MINISTRY OF SUPPLY (R.R.E.)

VALVE ELECTRONIC **CV2424-27**

Specification MOS/CV2424, 2425, 2426, 2427. Issue No. 2. dated 15. 1. 59. To be read in conjunction with K1006 and with MIL-E-1/9790 dated 18th June, 1957.	Security Specification: Restricted Valve: Unclassified
Type of Valves: Pulse Magnetron, Fixed Frequency Prototype: 4J50A. with different frequency range, and additional rugged features. (VX9170, VX2519).	MARKING See K1001/4 Additional Markings:- Serial No. .....
RATING RATING as on Page 1 of MIL-E-1/9790 with additions as in notes AA-CC.	Connections and Dimensions As MIL-E-1/9790 plus dimensioned collar (Note GG).
TESTS TESTS as on Pages 2, 3 of MIL-E-1/9790 with additions as in notes AA, DD-GG.

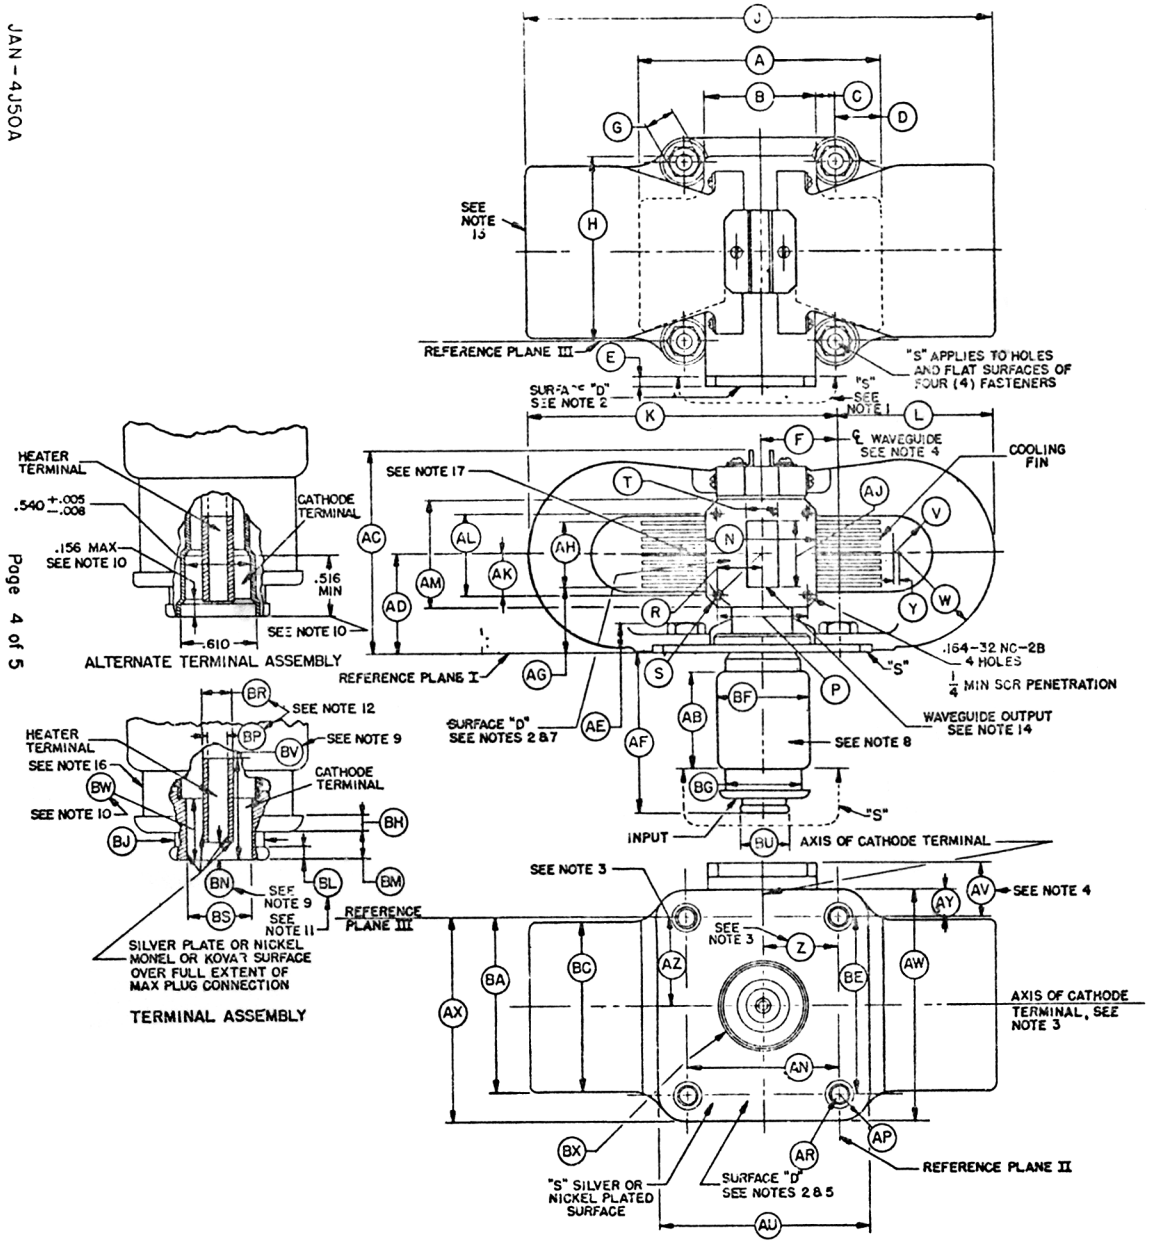
C.G. Page 2. Dimensions:- As drawing on Page 4. In addition the diameter of the undimensioned collar shall not exceed 1.375 inches. (See central projection and two left hand side scrap views).
